# EPC DPW Stormwater\_2026-06-10\_008 - Construction Documents.pdf Markup Summary

**Subject:** Engineer  
**Page Label:** [4] 4 Site Plan  
**Author:** Bret Dilts - DPW Engineering

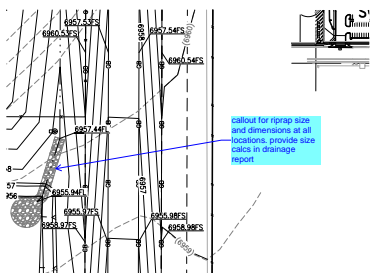
be sure to show the complete extent of the work

**RESPONSE: PLANS UPDATED**

**Subject:** Engineer  
**Page Label:** [12] 12 Southeast Grading Plan  
**Author:** Bret Dilts - DPW Engineering

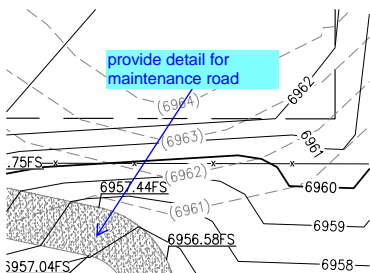
callout for riprap size and dimensions at all locations. provide size calcs in drainage report

**RESPONSE: SIZING INCLUDED ON PLANS. CALCULATIONS INCLUDED IN DRAINAGE REPORT.**

**Subject:** Engineer  
**Page Label:** [52] G-8 Final Erosion Control Plan South  
**Author:** Bret Dilts - DPW Engineering

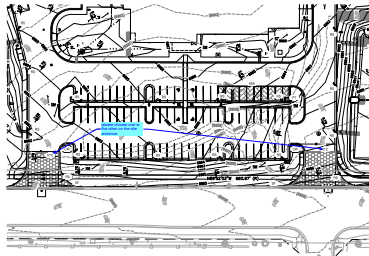
please choose one or the other on the site entrance

**RESPONSE: UPDATED TO SHOW WEST ACCESS AS MAIN CONSTRUCTION ENTRANCE**

**Subject:** SW - Textbox with Arrow  
**Page Label:** [12] 12 Southeast Grading Plan  
**Author:** EPC Stormwater- Zachary

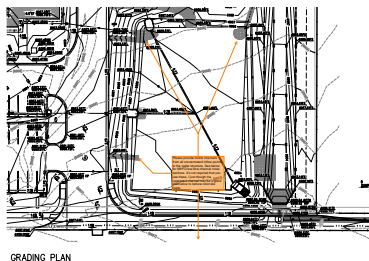
Please provide trickle channels from all concentrated inflow points to the outlet structure. See below for MHFD low flow channel cross sections. It's not required that you use these, I just thought the vegetated channel may be a good alternative to reduce concrete costs.

**RESPONSE: TRICKLE CHANNELS PROVIDED**

**Subject:** SW - Textbox with Arrow  
**Page Label:** [12] 12 Southeast Grading Plan  
**Author:** EPC Stormwater- Zachary

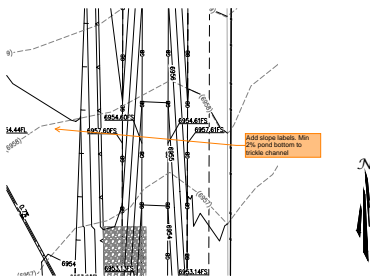
What is the width of the top of the embankment? Min 12' is required for maintenance access around pond.

**RESPONSE: WIDTH IS 12' WIDE**

**Subject:** SW - Textbox with Arrow  
**Page Label:** [15] 15 Stormwater Plan  
**Author:** EPC Stormwater- Zachary

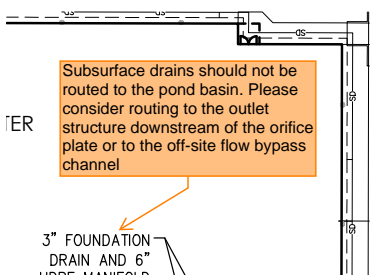
Provide details for riprap rundowns, micropool, and trickle channel

**RESPONSE: DETAILS PROVIDED**

**Subject:** SW - Textbox with Arrow  
**Page Label:** [20] 20 Outlet Structure Detail  
**Author:** EPC Stormwater- Zachary

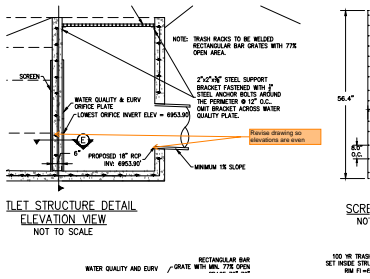
Orifice size does not match calcs

**RESPONSE: DETAIL UPDATED**

**Subject:** Cloud+  
**Page Label:** [13] 13 Grading Details  
**Author:** Laura Besler

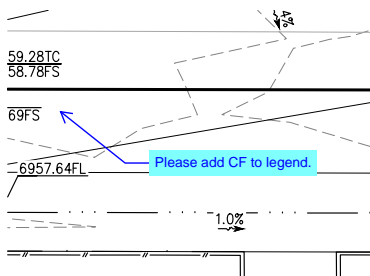
It appears that either the ADA ramp layout or the grading was revised without updating the other, including the associated spot elevations. Please revise for consistency.

**RESPONSE: UPDATED PLANS**

**Subject:** Callout  
**Page Label:** [16] 16 Stormwater P&P  
**Author:** Laura Besler

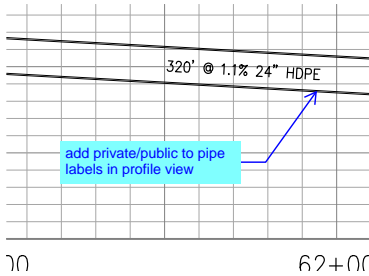
PRIVATE

RESPONSE: ADDED

**Subject:** Callout  
**Page Label:** [35] 35 Offsite Storm P&P 3  
**Author:** Laura Besler

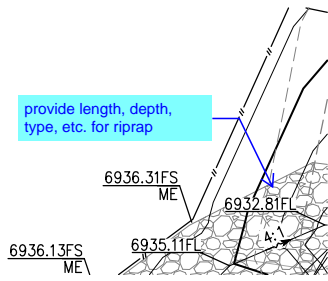
Show 200 feet downstream of outfall in profile, Q100 water surface elevation downstream of outfall

RESPONSE: ADDED TO PLANS

**Subject:** Callout  
**Page Label:** [35] 35 Offsite Storm P&P 3  
**Author:** Laura Besler

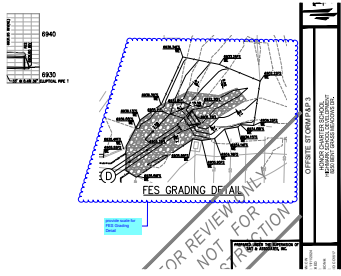
provide length, depth, type, etc. for riprap

**RESPONSE: ADDED TO PLANS**
